Technical Bulletin

Model
928

Subject: Camshaft/Sealing

Number
78-03

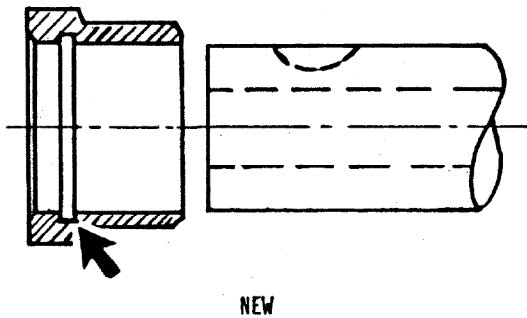
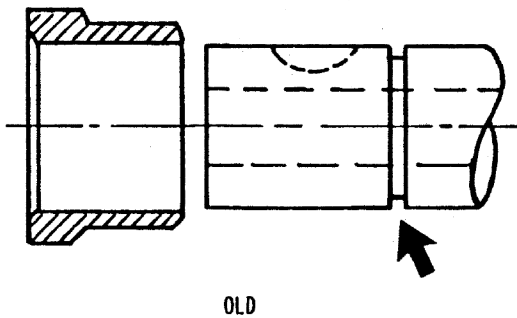
Camshaft/spacers have been modified for improved sealing.

O-ring has been moved from camshafts to spacers (arrow).

New-type camshafts no longer have groove (arrow).

New-type spacers with O-ring can be installed on old-type camshafts.

When new-type camshafts are installed in earlier engines, matching bearing carrier must be modified
